CITY COUNCIL AGENDA ITEM

Subject: PUBLIC HEARING – PRELIMINARY SITE PLAN REVIEW (SP JPLN2021-0028) - Proposed Golden Villas One Family Residential Cluster, South side of Square Lake, West of Dequindre (PIN 88-20-12-200-031 & 88-20-12-200-035), Section 12, Currently Zoned R-1C (One Family Residential) District

Preliminary Site Condominium Cluster Review For City of Troy, Michigan

Project Name:	Golden Villas
Plan Date:	February 28, 2022
Location:	South of E. Square Lake, west of Dequindre
Zoning:	R-1C, One-family Residential District
Action Requested:	Preliminary Site Condominium Cluster Approval
Required Information:	Deficiencies noted.

FRONT ELEVATION
SCALE: 1/4" = 1'-0"
D

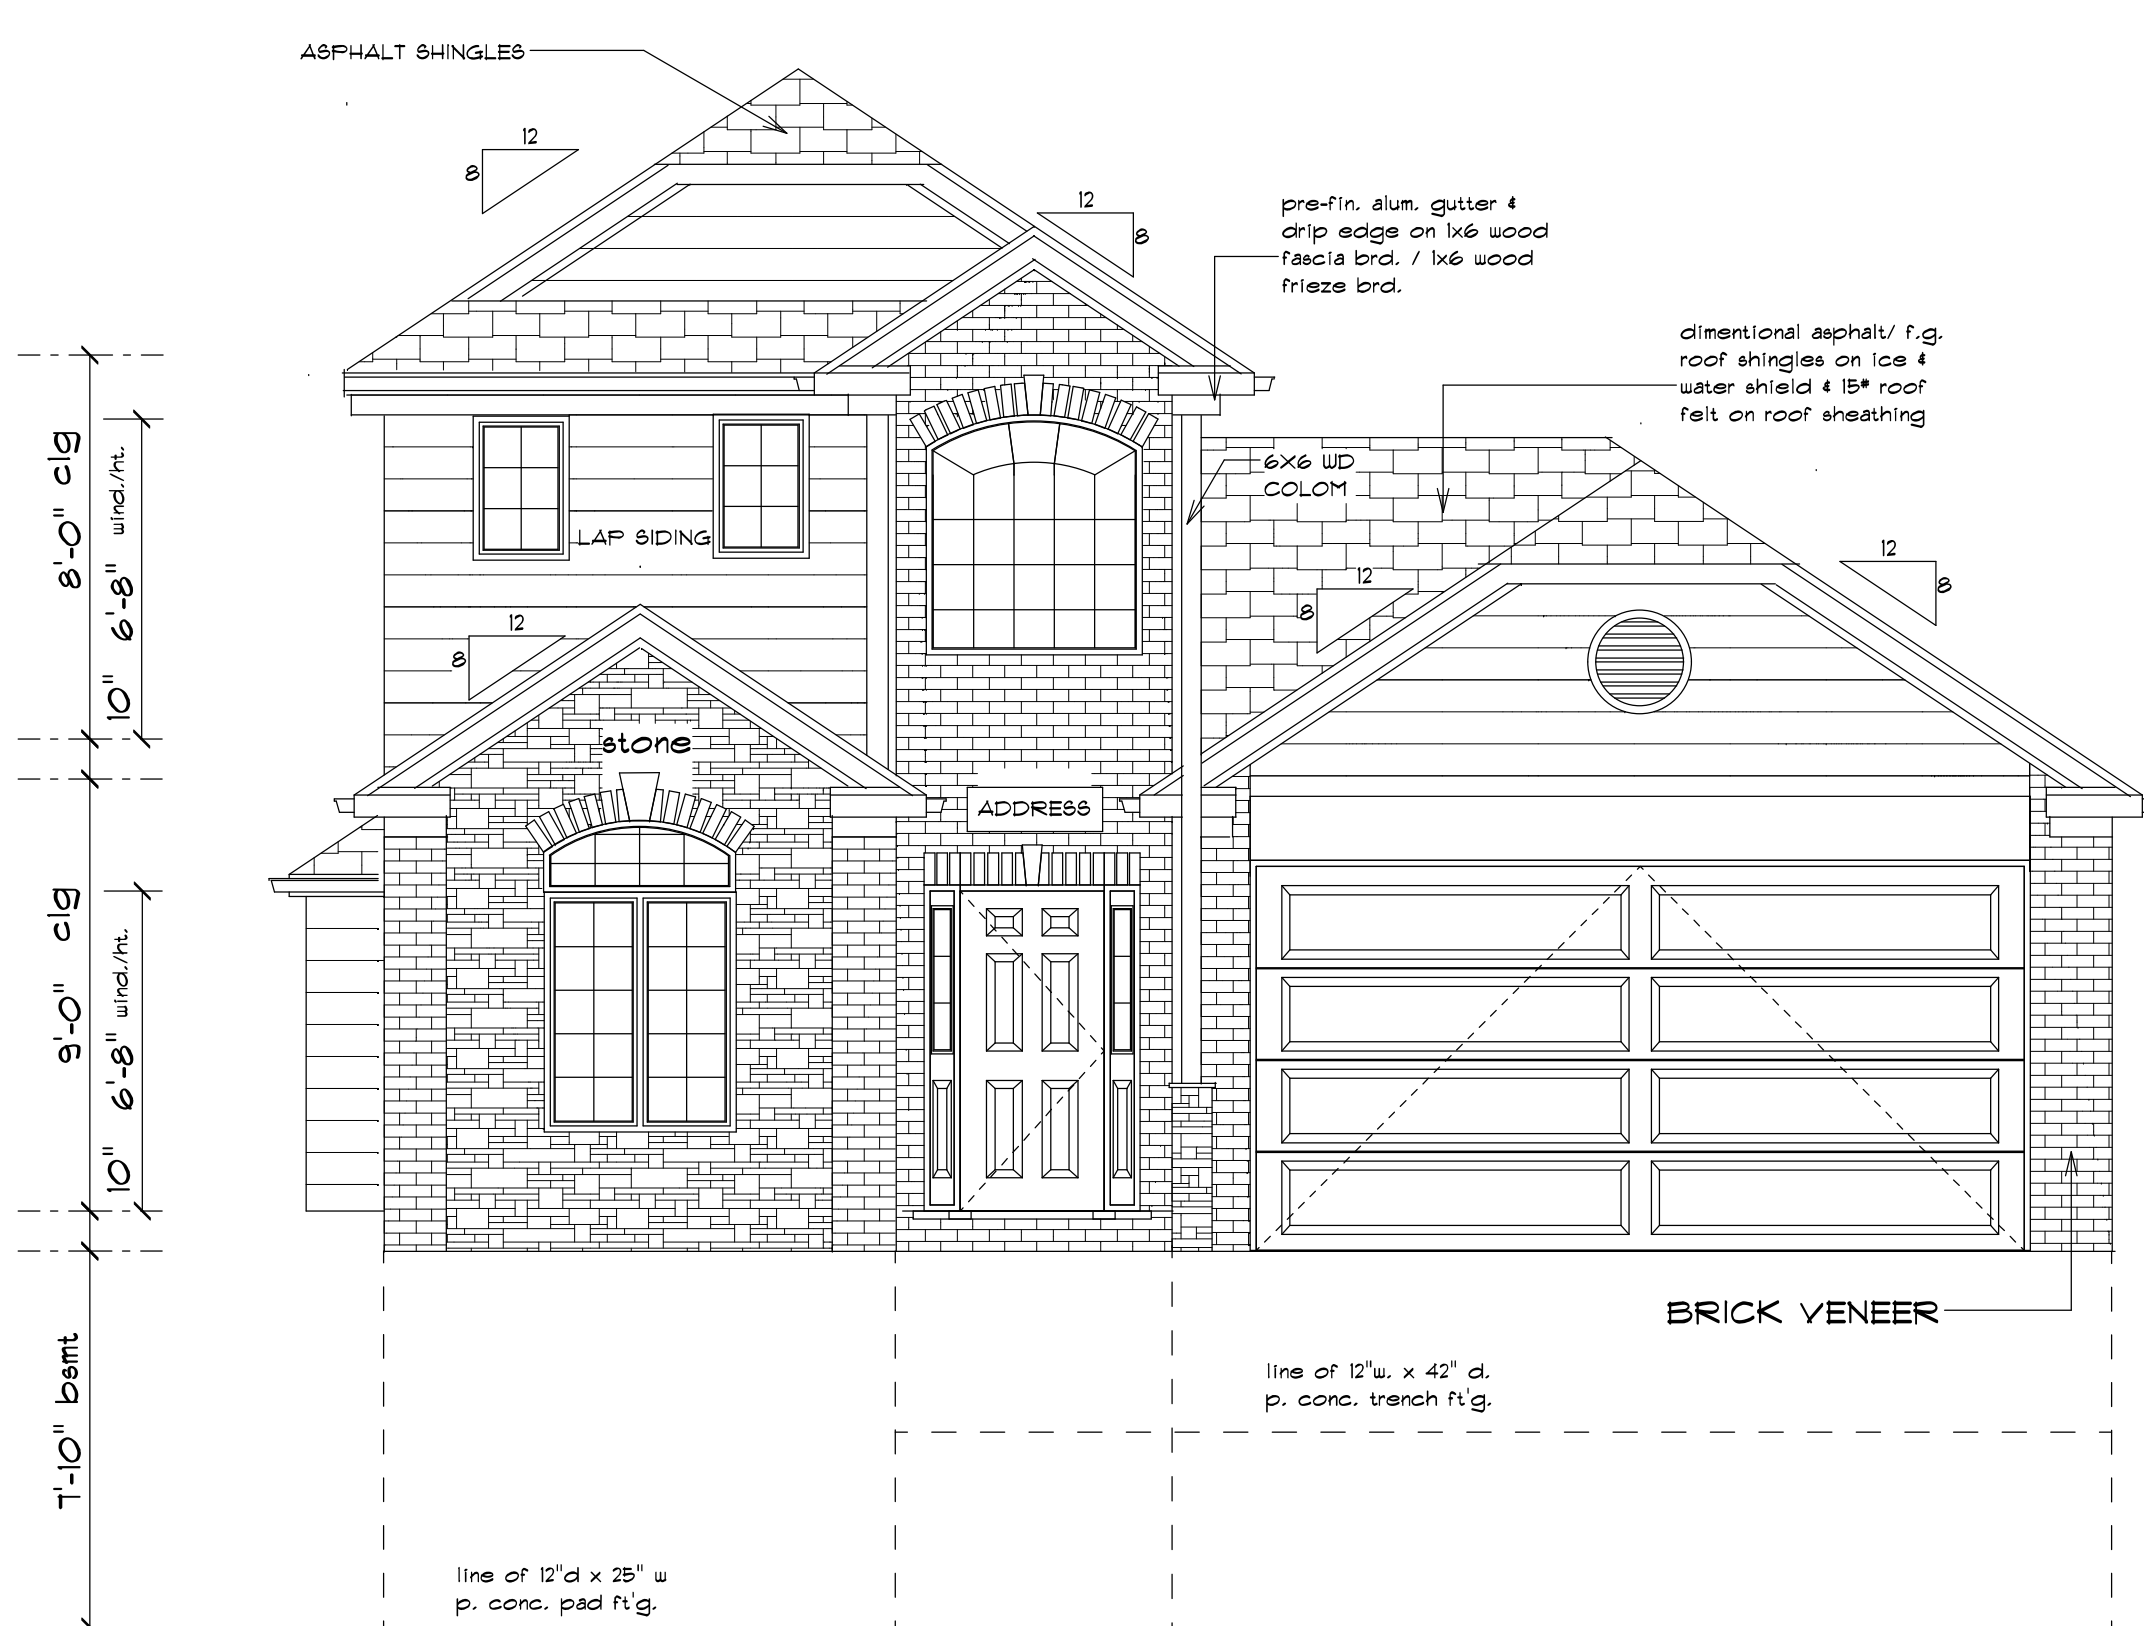
The applicant has submitted one housing options with a square footage up to 1,900. The applicant shall supply additional housing elevation options. Materials include brick, stone, and cedar veneer.

Items to be Addressed: Provide additional housing elevation options

The petitioner submitted a Landscape Plan with the additional twenty (20) trees along Square Lake Road. The petitioner has provided numerous additional housing elevation options which were included with the site plan. The petitioner has agreed that the exterior elevations will not include vinyl siding. An Open Space Preservation Agreement will be required to be submitted and approved prior to Final Site Plan Approval.
